Date January 10, 2019  
To Town of Cumberland Planning Board  
From Carla Nixon, Town Planner  
Subject **Major Site Review: Belted Cow Office Building**

Subject: Peer Review of Belted Cow Amended Site Plan Application  
Lot 5, Cumberland Foreside Village  
Cumberland, Maine

As requested, Sevee & Maher Engineers, Inc. (SME) has completed a peer review of the amended Site Plan Application for the proposed Belted Cow Headquarters on Lot 5 of Cumberland Foreside Village, located off US Route One in Cumberland. The application materials received by SME were prepared by Walsh Engineering Associates (Walsh), and consist of:

## EXISTING CONDITIONS AND DEMOLITION PLAN

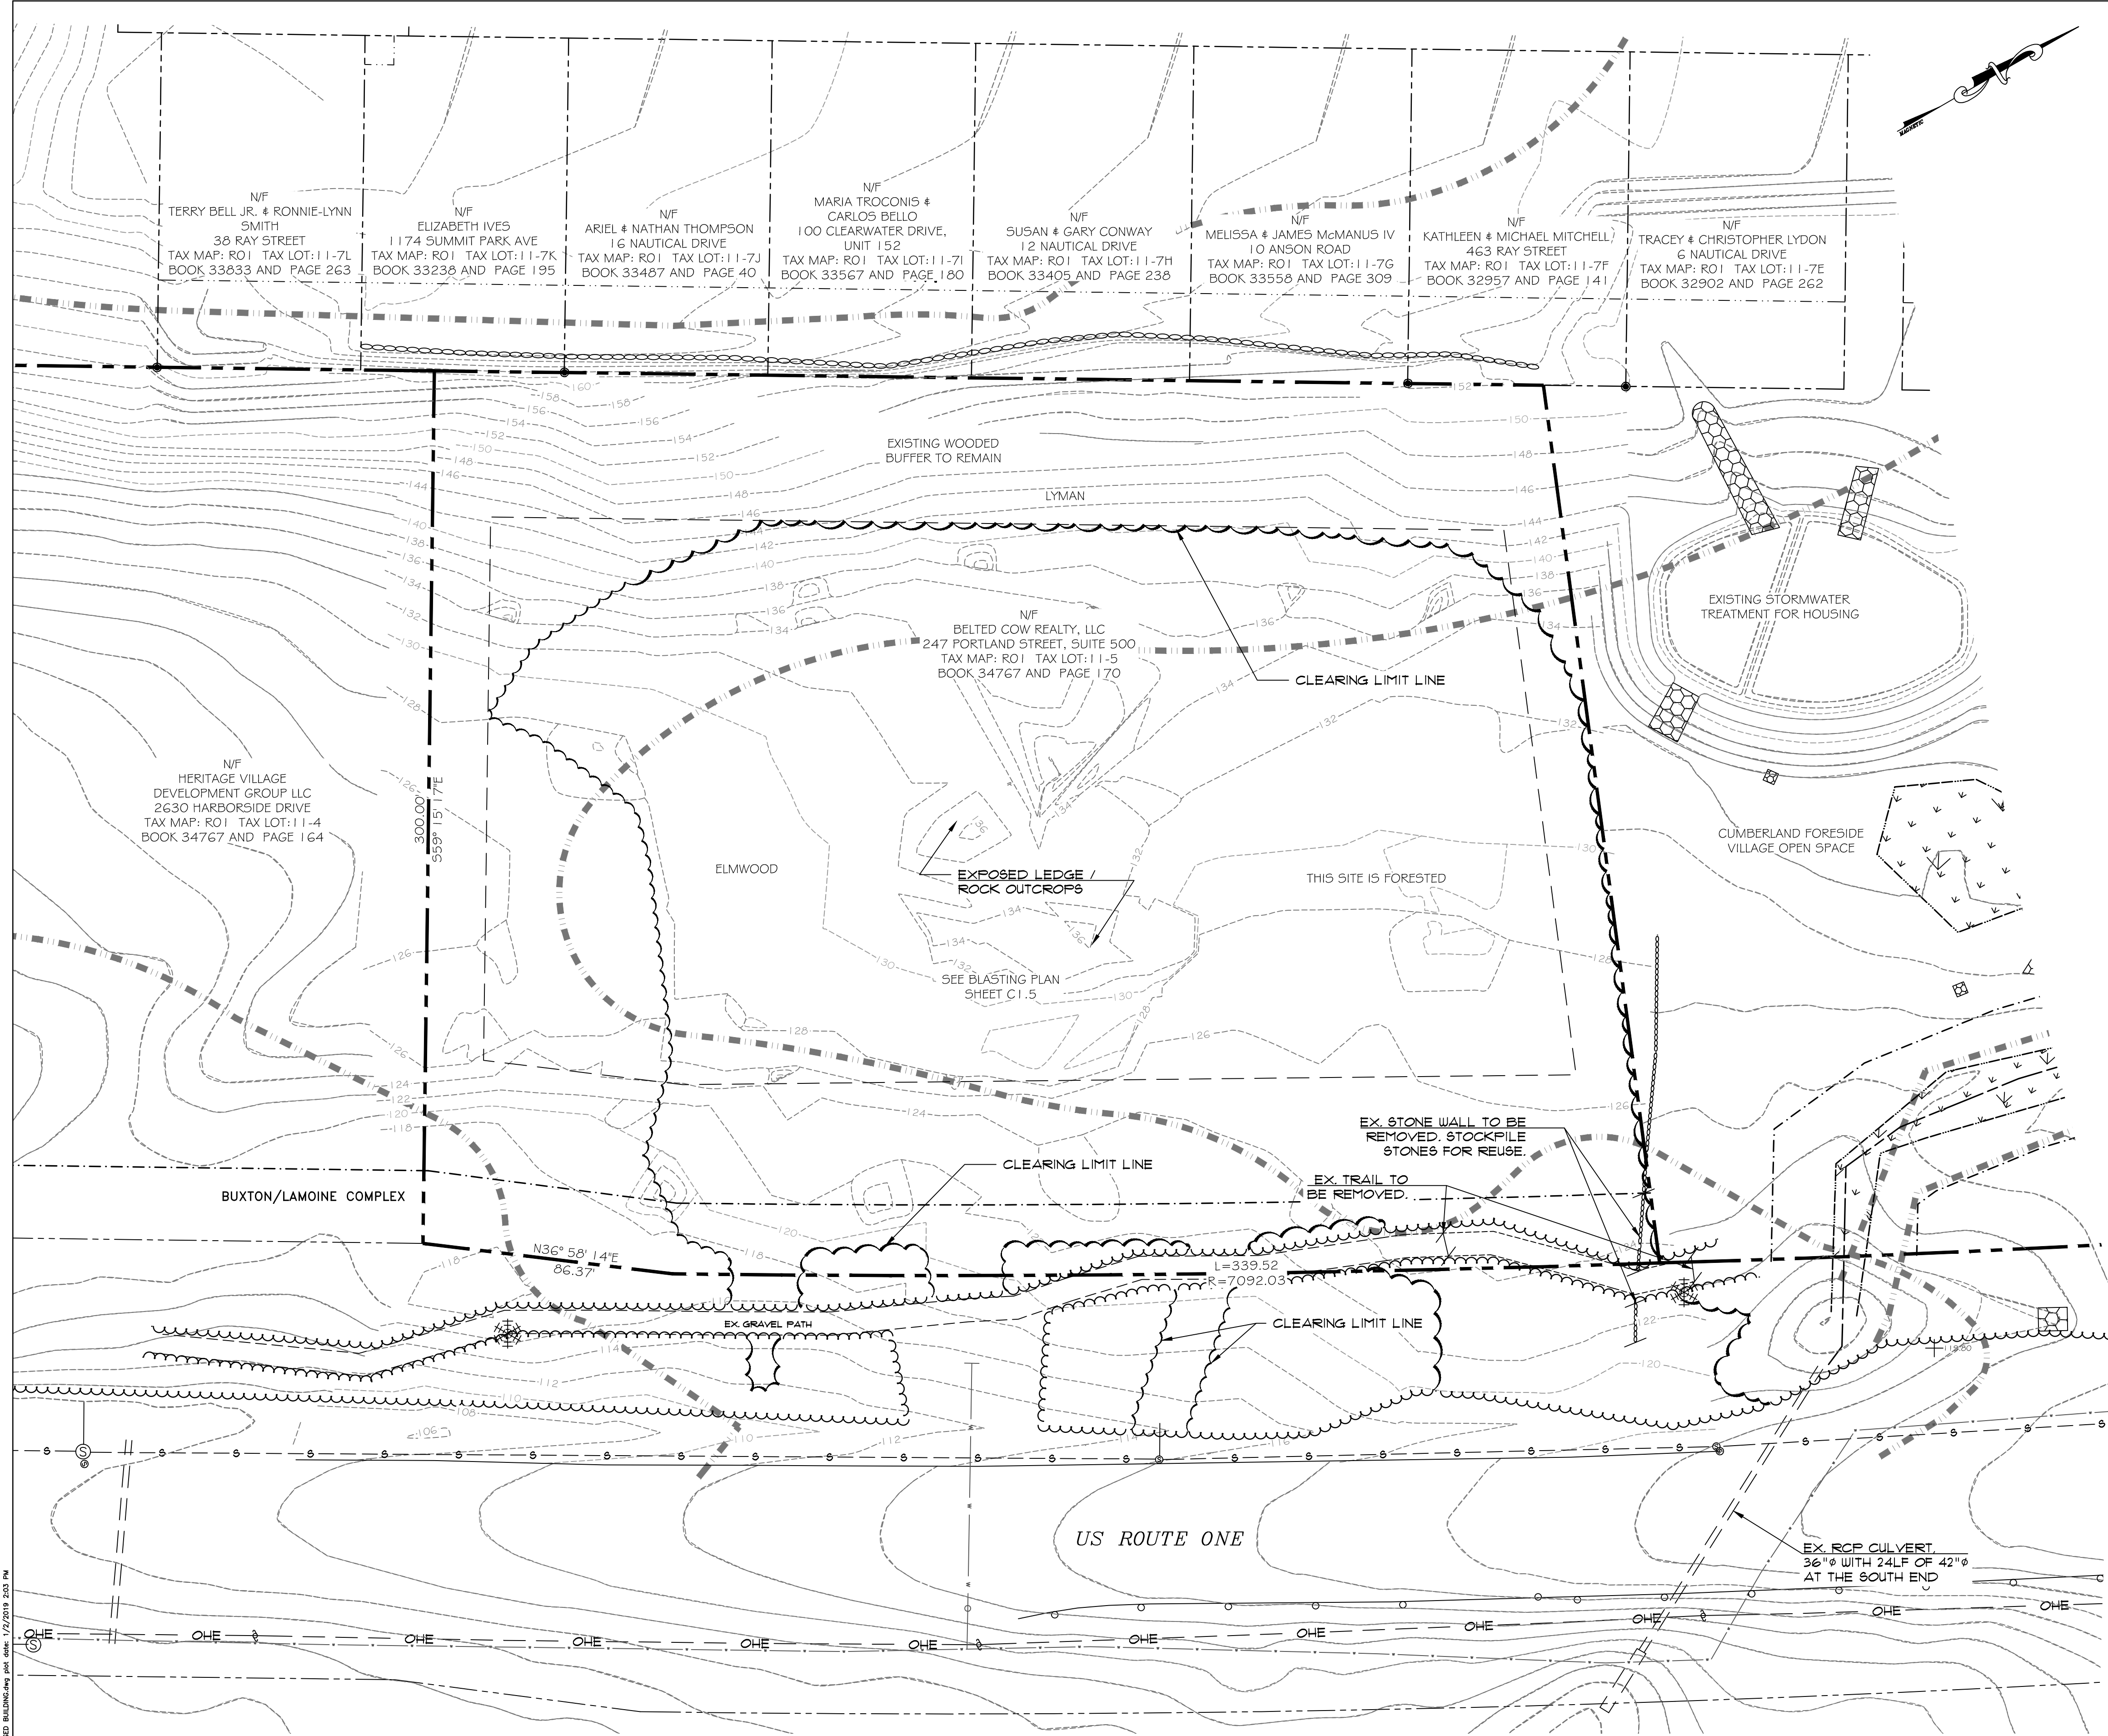
Plan sheet C1.1 (Existing Conditions) states trail to be removed. Clarify plan for trail relocation.

PARKING INFORMATION

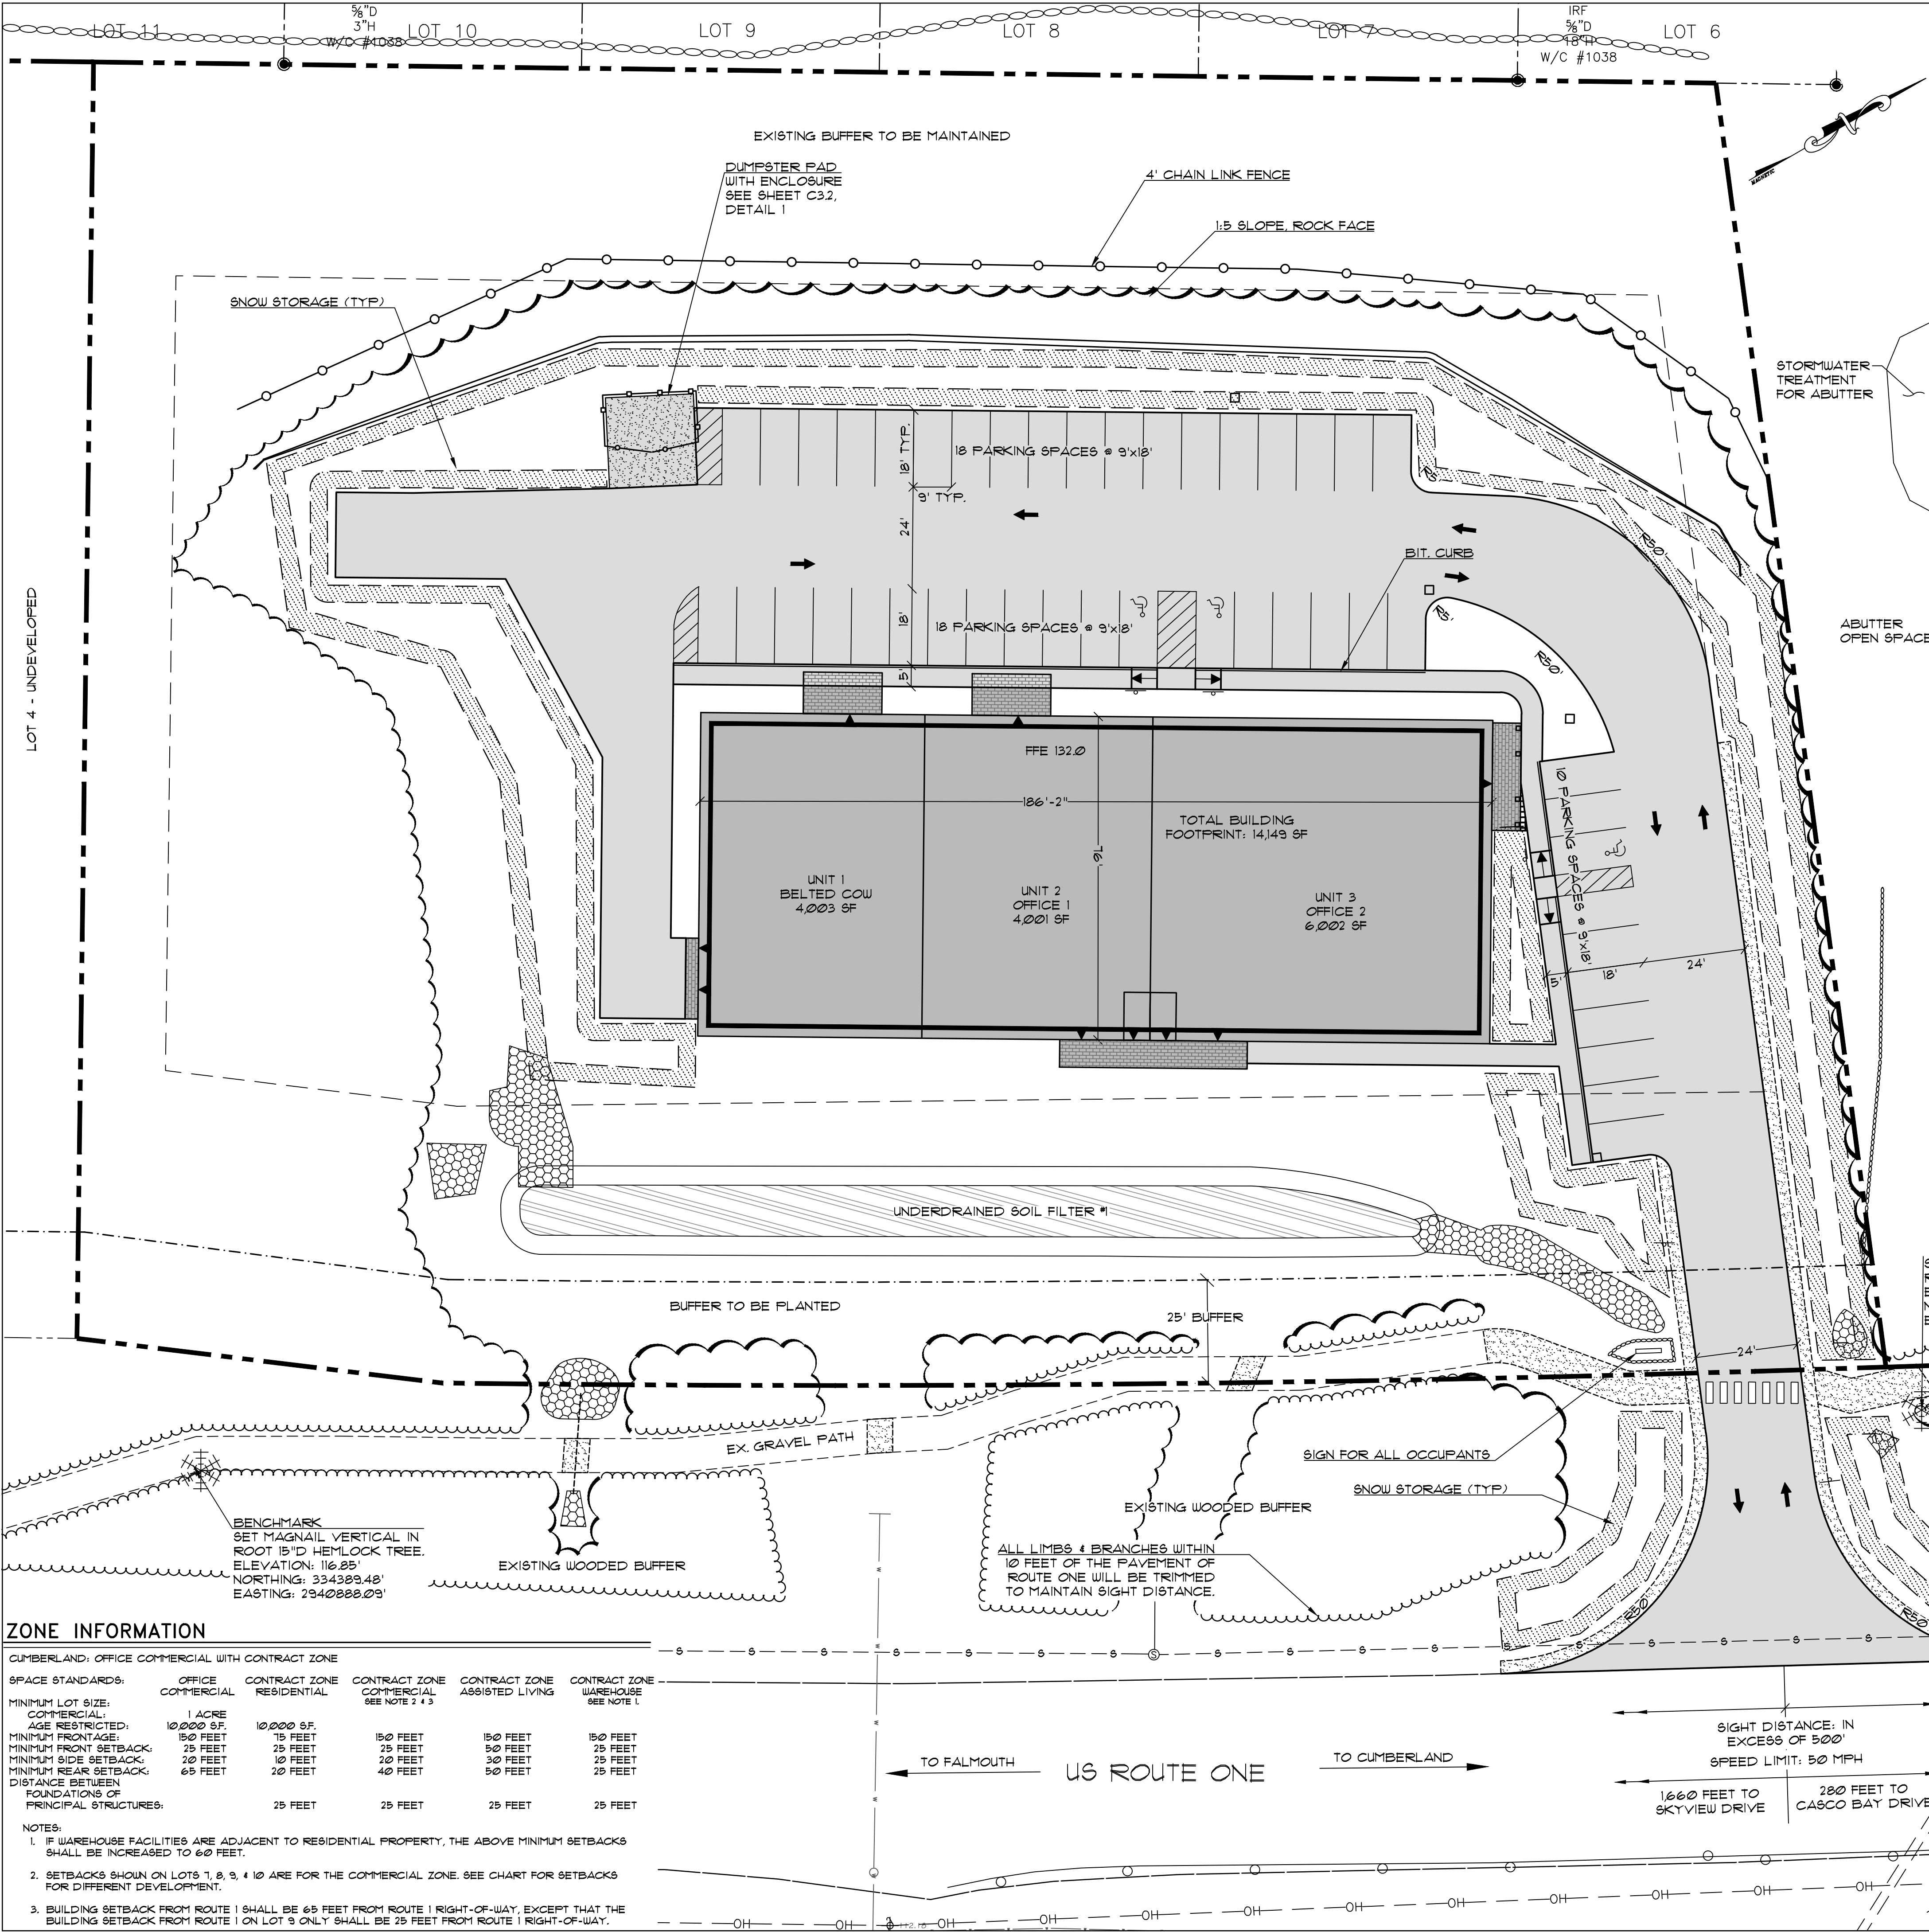
8. *This section outlines one parking space for each 250 square feet of gross leasable area for professional offices and business services, medical clinics and retail business in commercial districts. Site Plan C1.1 outlines one parking space for 304 square feet. SME recommends the applicant update the plan set to reflect the requirement or request a waiver.*

9. *SME recommends the applicant update the parking information and space per sf calculation on plan sheet C1.1 to reflect the revised 14,149-sf building footprint.*

10. *Plan sheet C1.1 outlines wetlands mapping is taken from a plan dated March 20, 2007. Industry standard generally requires updated mapping for surveys older than 5 years. SME recommends the applicant provide updated wetland information prior to final approval.*
